GOVERNMENT OF INDIA
MINISTRY OF ENVIRONMENT, FORESTS & CLIMATE CHANGE

Central Zoo Authority

F.No.19-127/93-CZA(180)(Vol.III)(Pt.)(AK)/7364 DATE: 24.06.2015

Subject:- Proposed revised designs for construction of enclosures at Nisargakanya Bahinabai Choudhary Pranisangrahalaya, Pimpri, Maharashtra – regarding

d. Revised design of proposed exhibit for Reptile of Ghats:

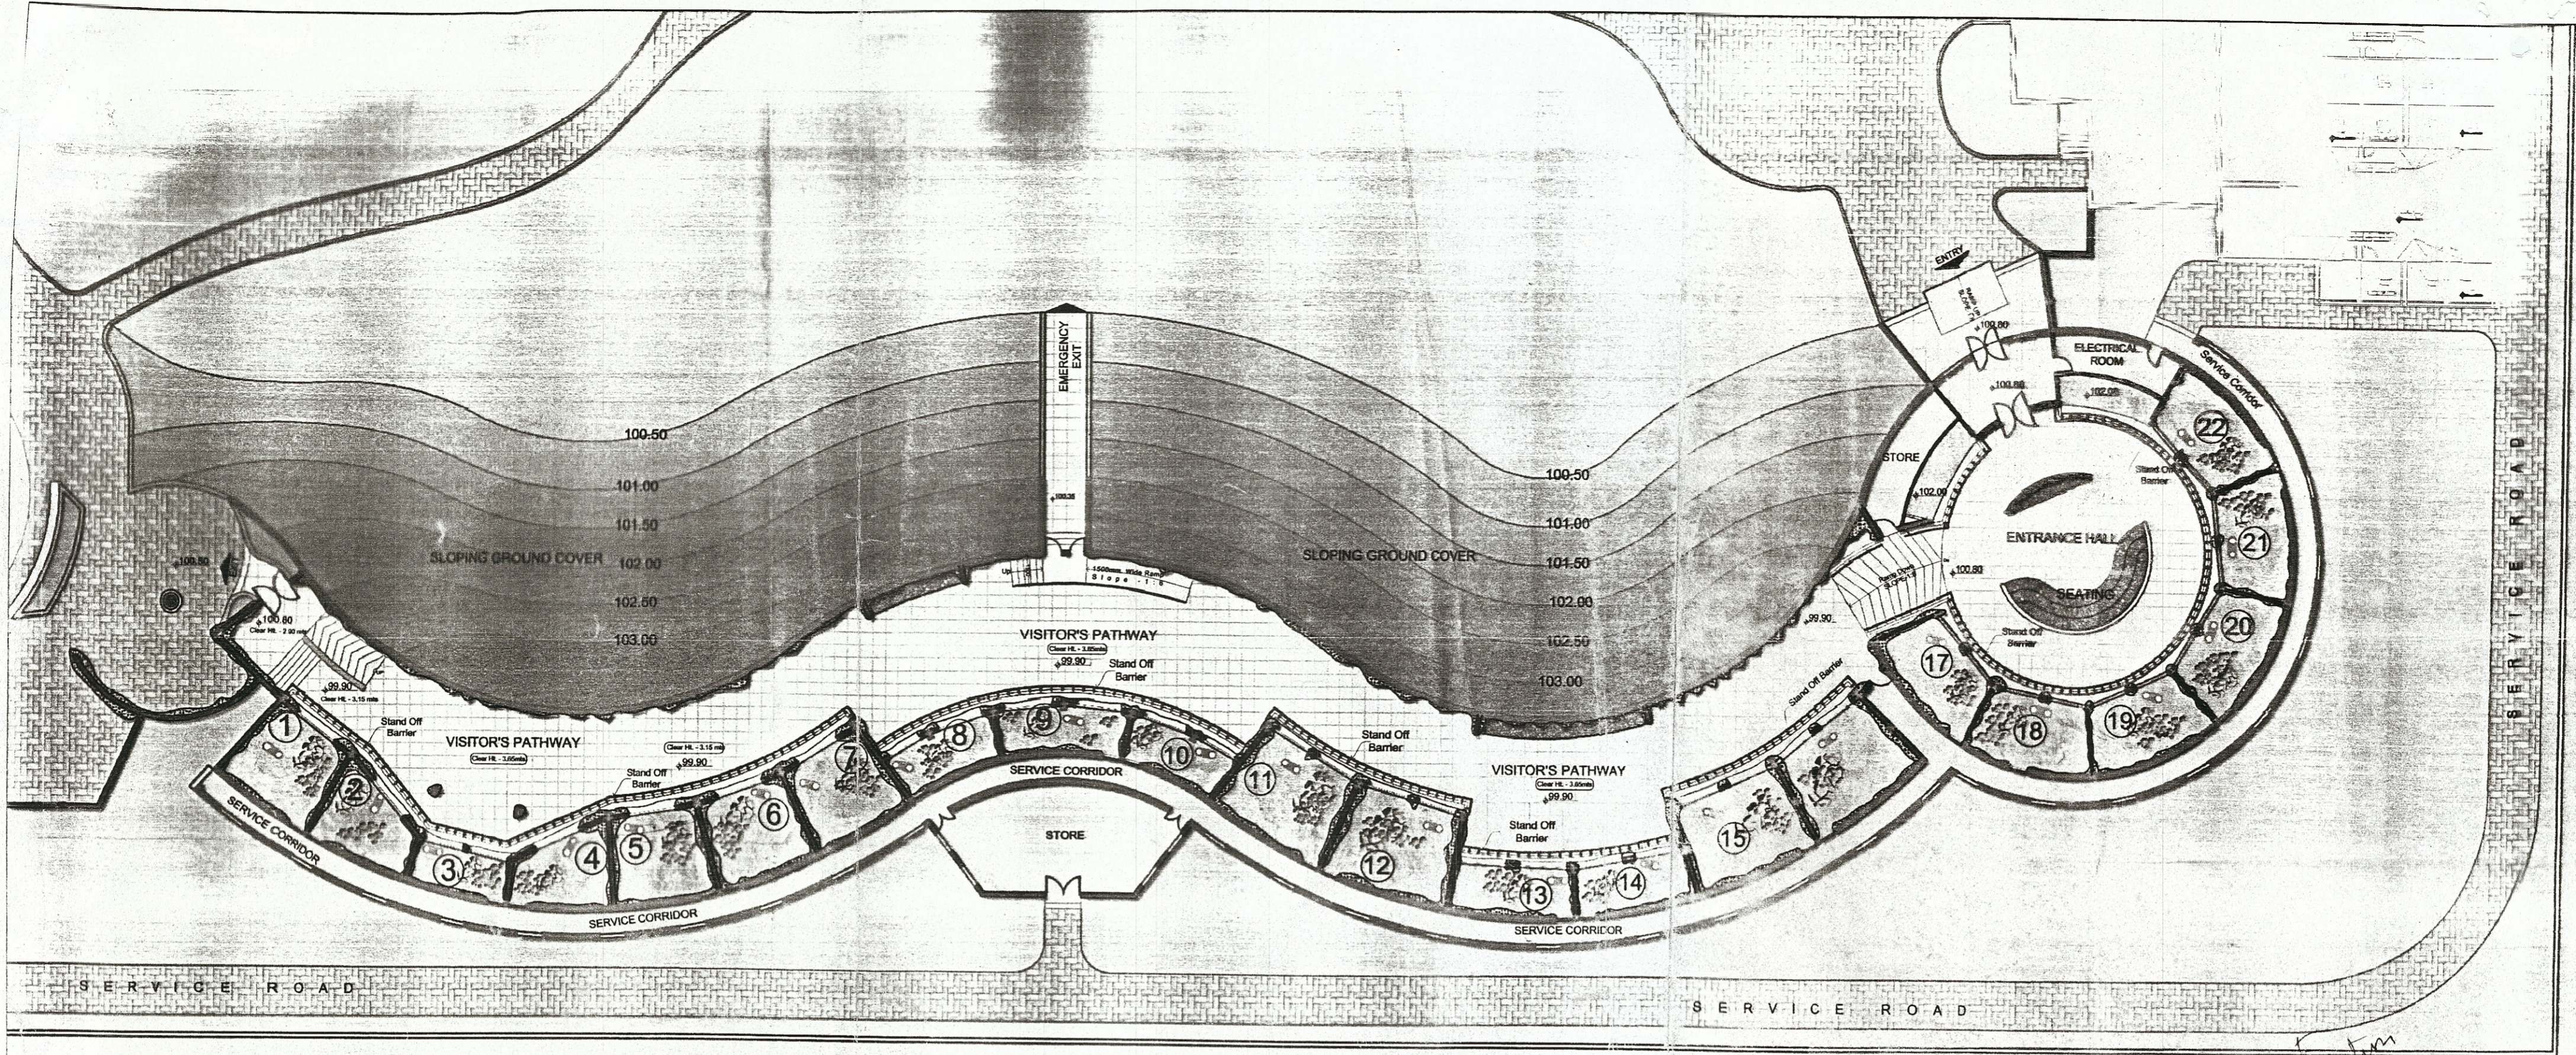
The revised design was scrutinised and approved subject to compliance with the following observations:

- i. The height of skylight glass from roof should be at least 2.5 feet as indicated.
- ii. The acrylic sheet covering skylight should be of poly carbonate and extend over the side by 1 foot.
- iii. Additional ventilation should be provided on the outer wall of visitors' path/corridor as indicated. There should be an overhang over the ventilation to prevent glare on the viewing glass.

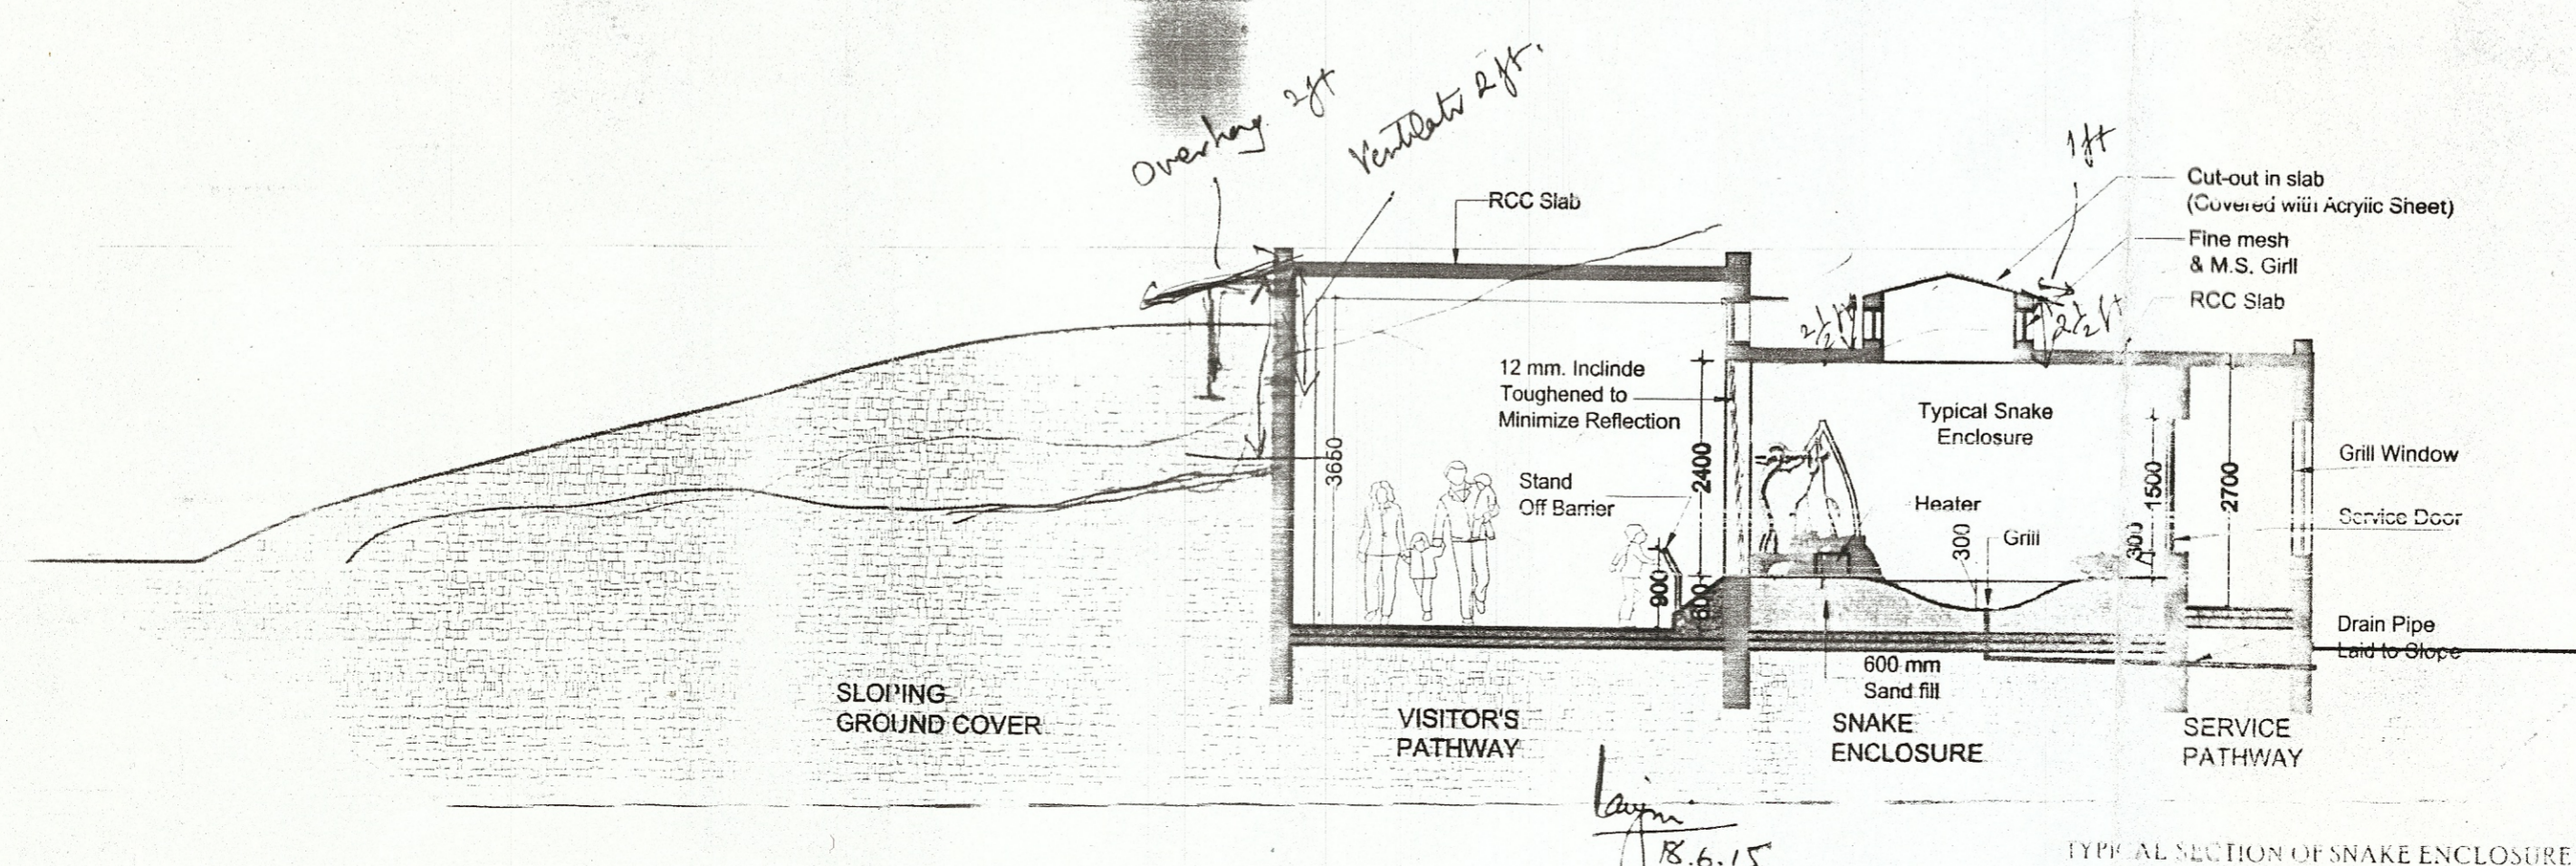
Approved layout & the following observation

- LAYOUT PLAN OF REPTILE OF GHATS
- ① The height of skylight glass from floor should be atleast 2ft as indicated
 - ② The acrylic sheet cover skylight should be of poly carbonate and extend over the side by 1ft
 - ③ The Additional ventilation should be provided on the outer wall of visitor path/corridor as indicated. This should be an overhang with the ventilation to prevent glare on the viewing glass.
